NO CHANGE OF USE OR OCCUPANCY
CLEAR MAX COLLISION
2425 WAYSIDE COURT
COLORADO SPRINGS, CO
NEW PAINT BOOTH

PCD File # PPR 1916

Markup Summary

A SITE PLAN / ROOF PLAN
 S101 SCALE: 1" = 20'-0"

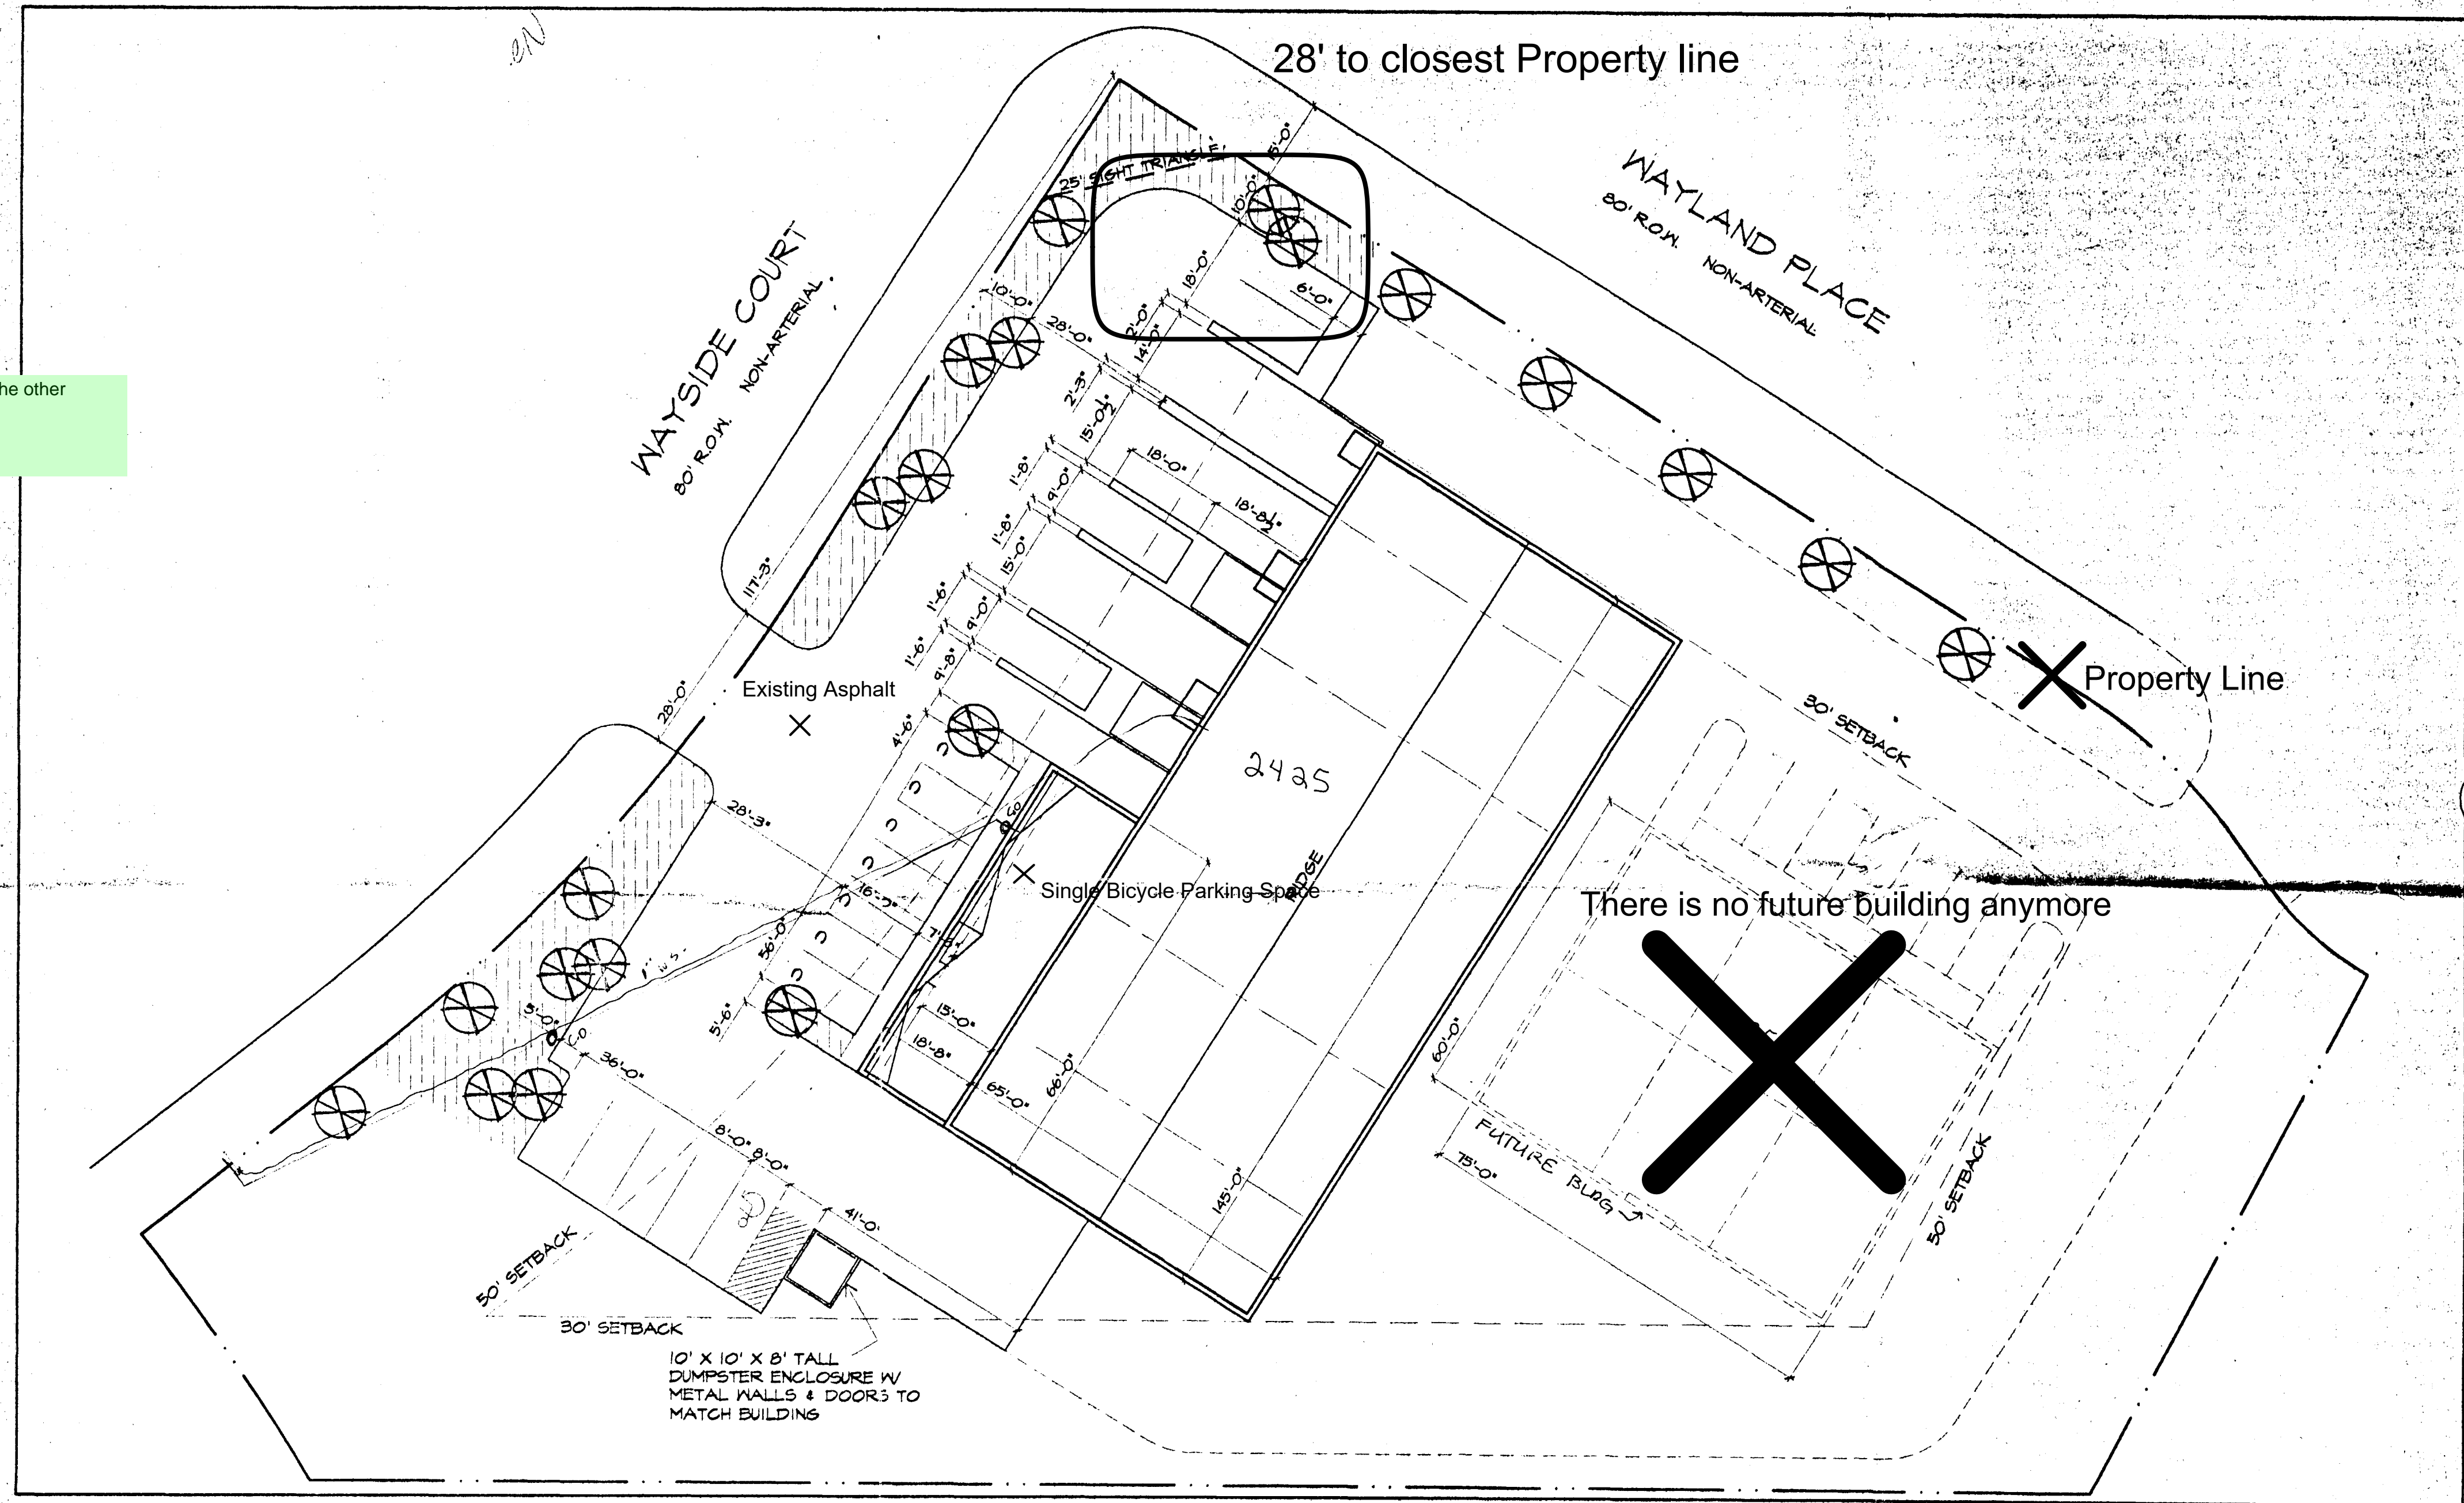
Remove pages 5-9 from this document. It is supposed to be just the floorplan drawings. We have the other drawings in another submittal item so no need for duplication.

Remove pages 5-9 from this document. It is supposed to be just the floorplan drawings. We have the other drawings in another submittal item so no need for duplication.
